Access Compliance Report

Public Rights-of-Way

(Pedestrian Signals)

Intersection ID: N/A	Main Street:	Cross Street: N/A	Location: N/A
ADA ID: AAFFB067CDFF	Signal Type: One Push Button-Non APS	Overall Compliance: No	Severity Score: BTN 1: N/A BTN 2: N/A No BTN: N/A
Codes/Mitigation Info/Possible Solution		Field Measurements/Component Compliance

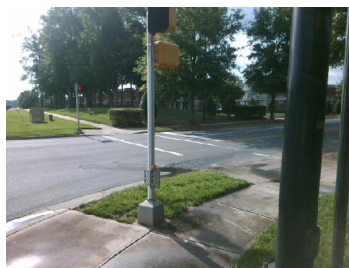
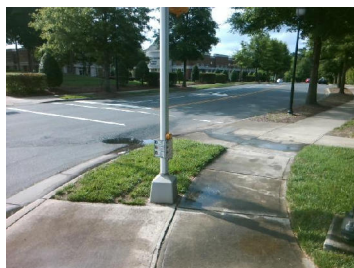
PROW/ADA: R406.2

N/A	B 1 FWD Approach Width (in)	60.0	N/A	B 2 FWD Approach Width (in)	N/A
N/A	B 1 FWD Approach Obstruction?	Yes	N/A	B 2 FWD Approach Obstruction?	N/A
N/A	B 1 FWD Approach Obstruction Dist (in)	5.0	N/A	B 2 FWD Approach ObstructionDist (in)	N/A
N/A	B 1 PARA Approach?	Yes	N/A	B 2 PARA Approach?	N/A
N/A	B 1 PARA Approach Constrained?	No	N/A	B 2 PARA Approach Constrained?	N/A
Yes	B 1 PARA Approach Reach (in)	7.0	N/A	B 2 PARA Approach Reach (in)	N/A
N/A	B 1 PARA Approach Width (in)	60.0	N/A	B 2 PARA Approach Width (in)	N/A
N/A	B 1 PARA Approach Obstruction?	Yes	N/A	B 2 PARA Approach Obstruction?	N/A
N/A	B 1 PARA Approach Obstruction Dist (in)	5.0	N/A	B 2 PARA Approach ObstructionDist (in)	N/A
Yes	B 1 Clear Floor Space Slope (%)	0.1	N/A	B 2 Clear Floor Space Slope (%)	N/A
Yes	B 1 Clear Floor Space XSlope (%)	0.7	N/A	B 2 Clear Floor Space XSlope (%)	N/A
N/A	B 1 PAR Slope (%)	1.5	N/A	B 2 PAR Slope (%)	N/A
Yes	B 1 Height (in)	37.0	N/A	B 2 Height (in)	N/A

Possible Solutions: Provide Push Button Extension.
